**Re: 1199 West Central Street – Garelick Farms  
MassDEP File No. 159-1322  
Notice of Intent Peer Review #2**

BETA Group, Inc. (BETA) has reviewed revised documents and plans for the project entitled **Garelick Farms Flood Resiliency Improvements** (the Project), located at **1199 West Central Street** (the Site) in Franklin, Massachusetts. This letter is provided to present BETA's findings, comments and recommendations.

## PERMIT DRAWINGS SEPTEMBER 2025 REVISED OCTOBER 2025 REVISED DECEMBER 2025 REVISED JANUARY 2026

**EROSION CONTROL BARRIER**  
NO SCALE

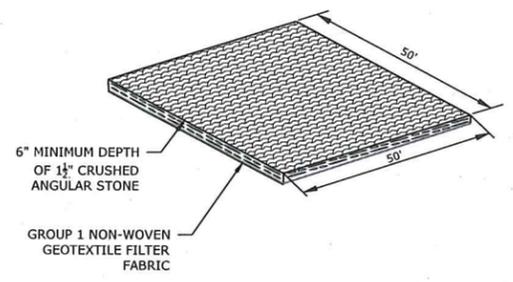
**BETA2: BETA defers to the Commission on the approval of the use of straw wattles as erosion controls, as they have discouraged their use in recent years. The use of silt fence and hay/straw bales is referenced within the soil stockpile detail on page C-501 within Section 3.3 of the O&M Plan and should be revised accordingly.**

### **T&B2: The detail on sheet C-501 has been revised to indicate the use of compost filter tubes, and the O&M Plan has been updated to remove references to straw wattles.**

**STONE OUTLET PROTECTION**

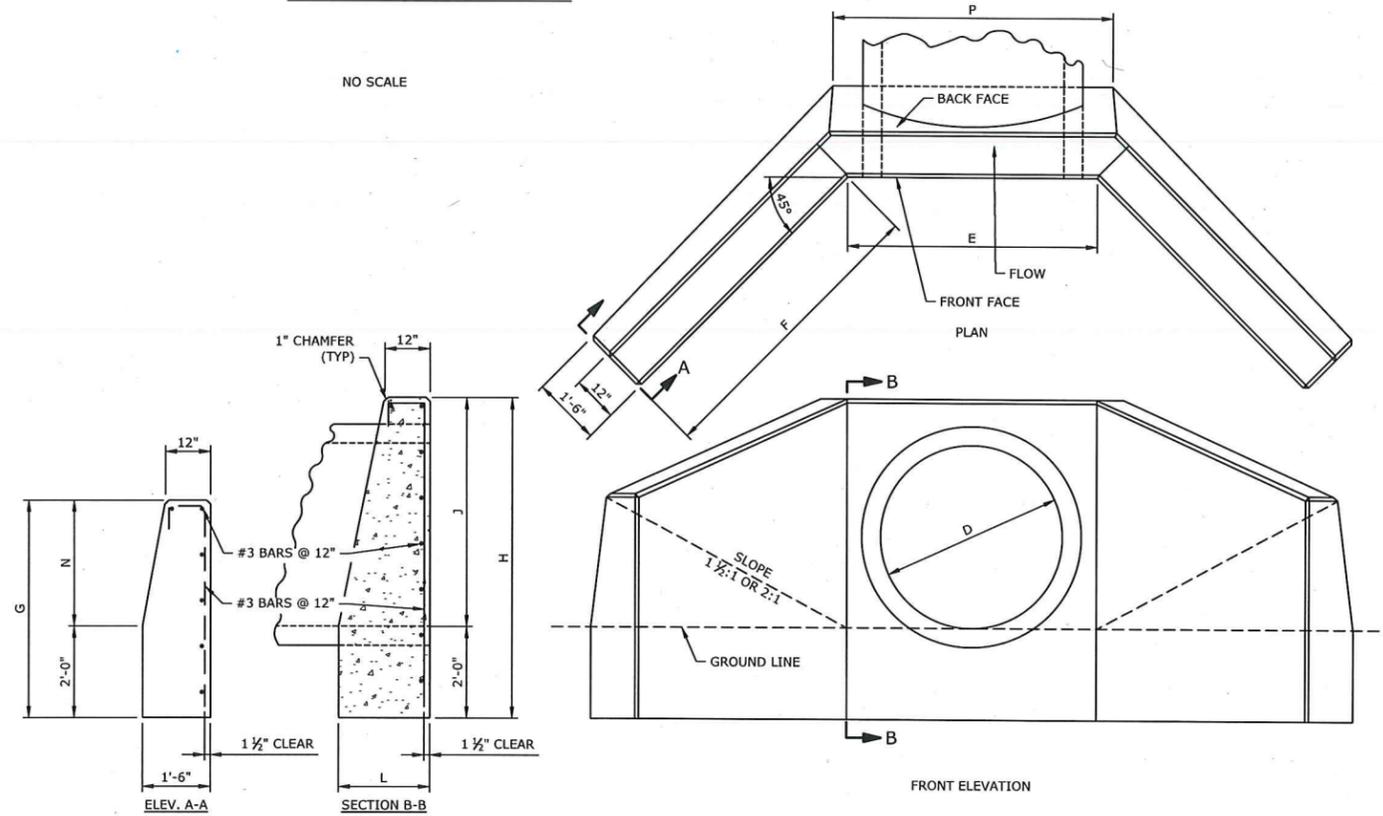
- SW3. The flared end section at the end of the proposed 36-inch pipe run discharges to a 3:1 ( $\pm$ ) slope. Additionally, the flared end section is oriented at an angle that is not perpendicular to the slope, which will render the riprap less effective. BETA recommends that the angle of the outlet pipe be reevaluated, and a concrete headwall be utilized to provide an effective flat area where the riprap can dissipate flows and prevent scouring.

*TB: The location of the proposed outfall was selected based on the required outfall elevation and relative proximity of the nearby wetland resource area. A system outlet elevation of 220.0 is required based on upstream drainage system elevations, as well as hydraulic pipe capacities. A perpendicular orientation of the proposed flared end section cannot be achieved at elevation 220.0 without direct impacts to wetlands. However, a winged headwall has been added to the project plans to allow for a flatter grade at the outlet, and adjustments to the riprap outfall protection configuration have been made. See sheet C-201 for updated outfall information.*
